NEWMAR CORPORATION WARRANTY DEPARTMENT

TECHNICAL SERVICE BULLETIN

DATE ISSUED	MODEL YEAR(S) AFFECTED	TSB #
11/04/2014	2014-2015 Essex	Recall 14V-620 TSB 411

Rear Jack "U" Channel and Airbag Clearance

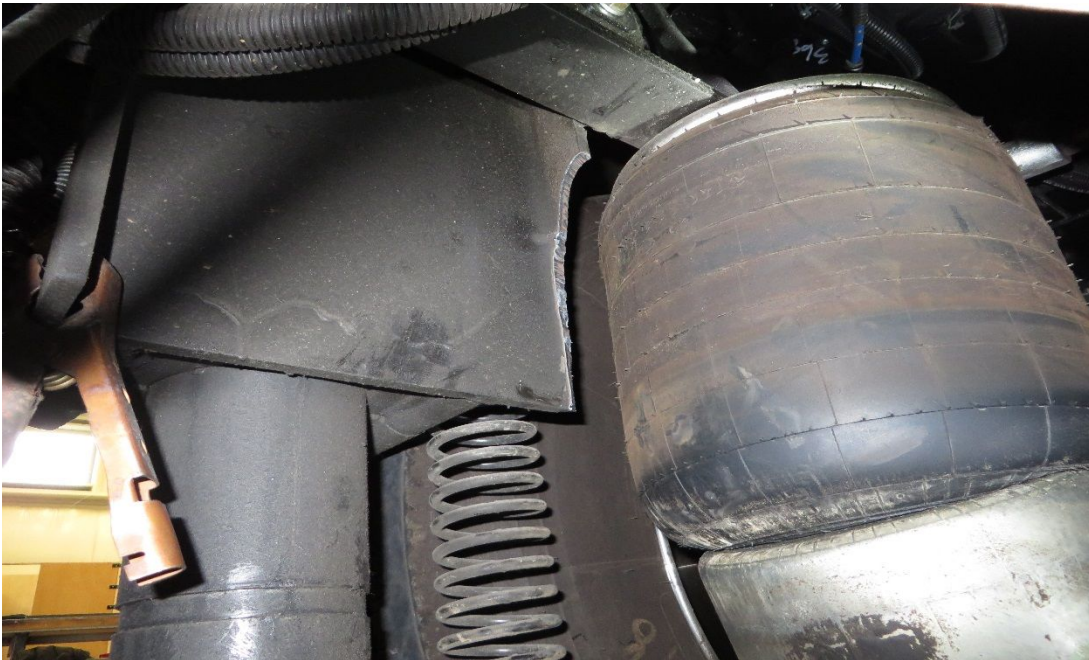
- Inspect both rear jacks "U" channel clearance to the airbag. There needs to be a minimum of 3/4 inch clearance showing from top to bottom.

- If less than 3/4 of inch is showing than the radius portion of the "U" channel will need removed. Place a protective blanket covering any exposed material (tires, harness, airlines and airbag). Place a metal plate between "U" channel and airbag.

- Starting below the chassis railing, cut the channel radius off down to the bottom edge of bracket.

- Paint the cut bracket edge with black paint to prevent rust. Remove protective blankets.
- Inspect and repeat process of other side of coach if needed.
- Inspect airbag for any damage. Replace airbag if any damage shows.

- The radius piece removed from bracket.
